SECTION 4.55 MODIFICATION

Modification to DA/538/2019

607 Canterbury Road, Belmore

Document Type: Section 4.55 Modification Report

Drawing Title:
Proposed Car Wash
Roof Plan

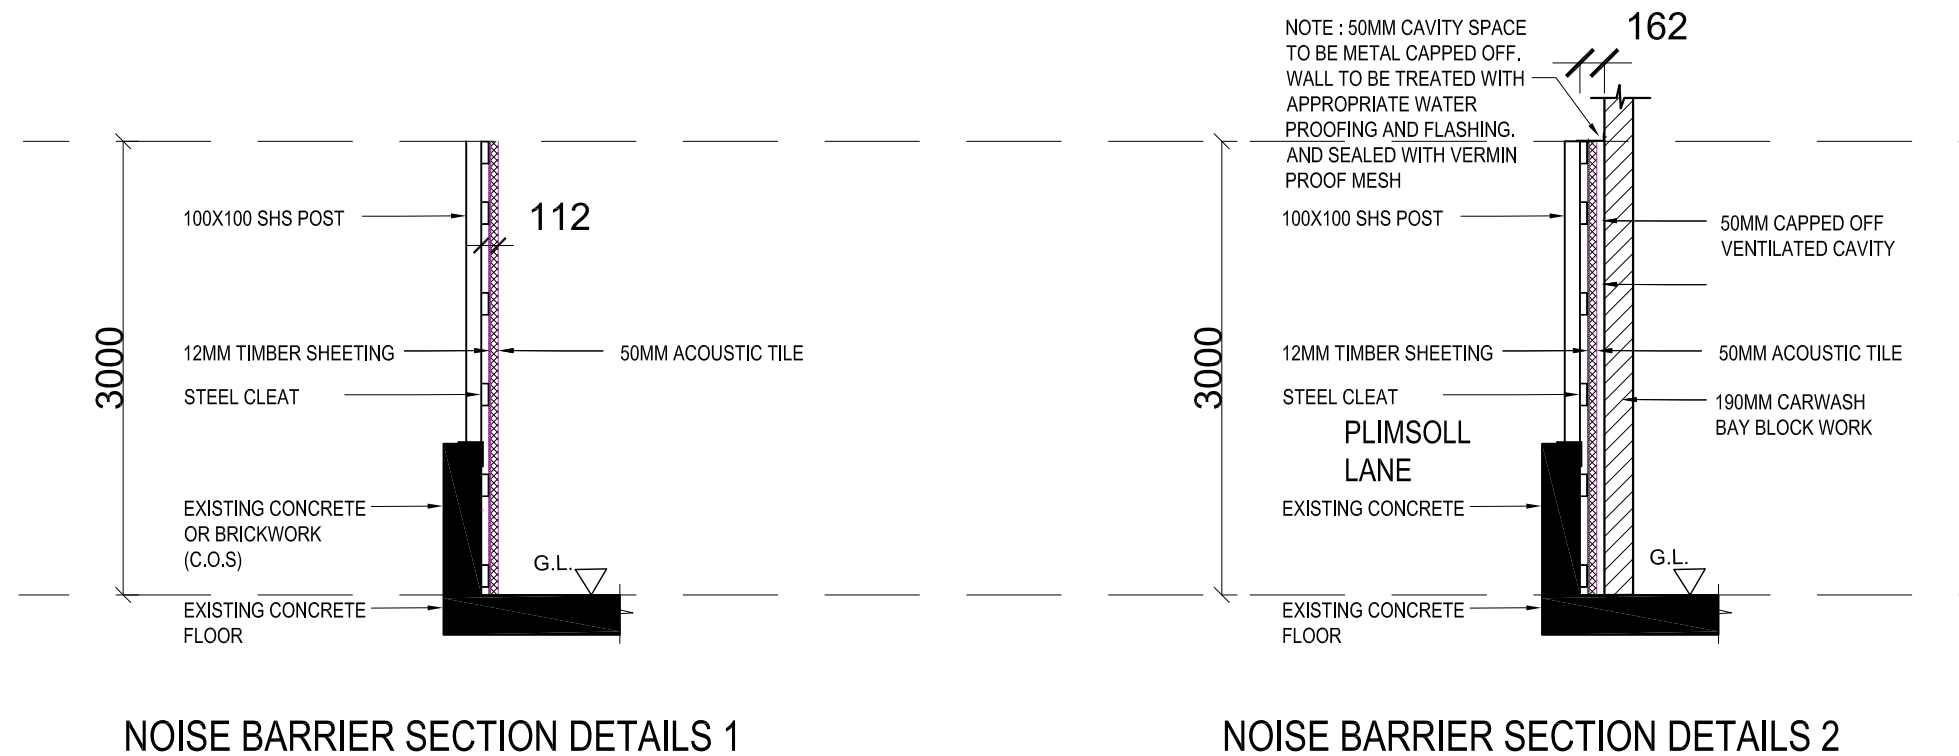
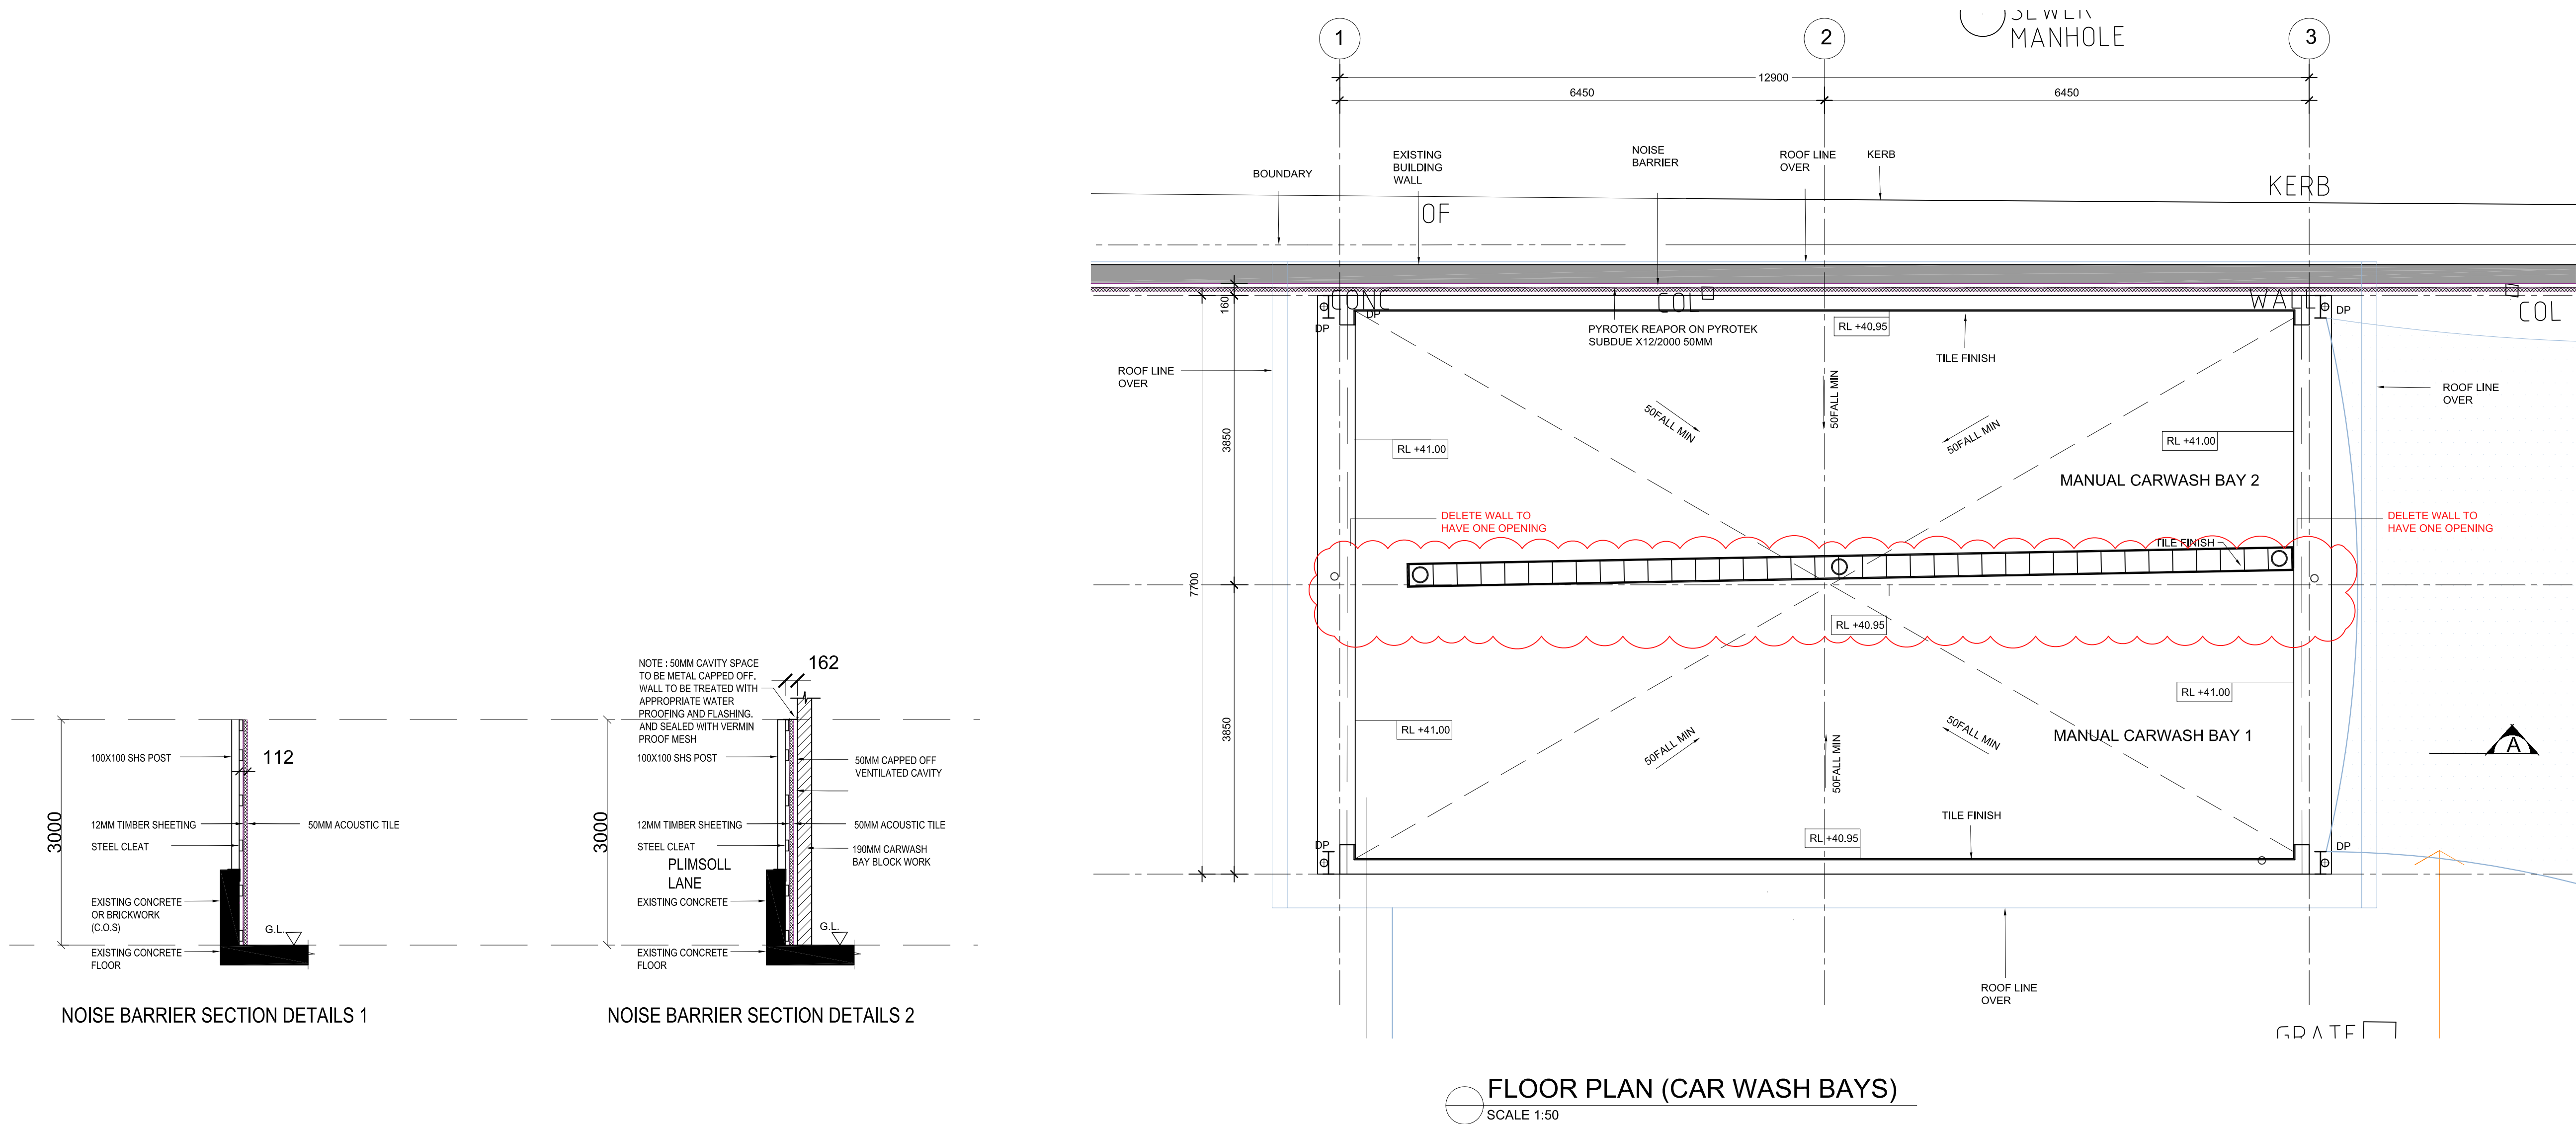
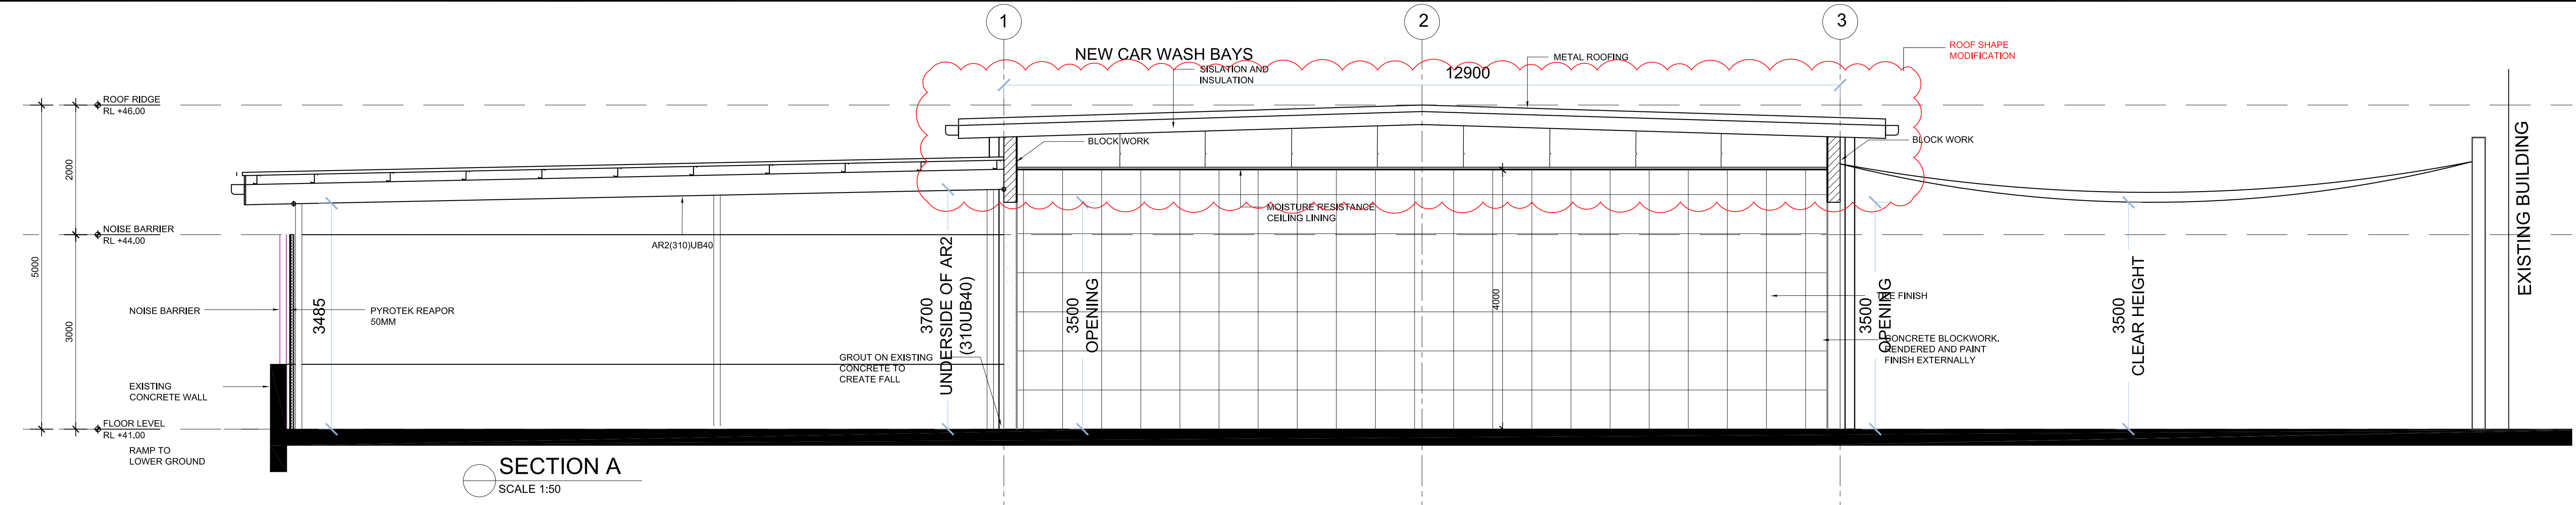
It is proposed to adopt minor modifications to the car wash bay structure. The roof shape of the car wash bay structure is to change from a curved roof shape to a pitched roof shape with a gentle roof pitch to allow rainwater to flow away from the roof.
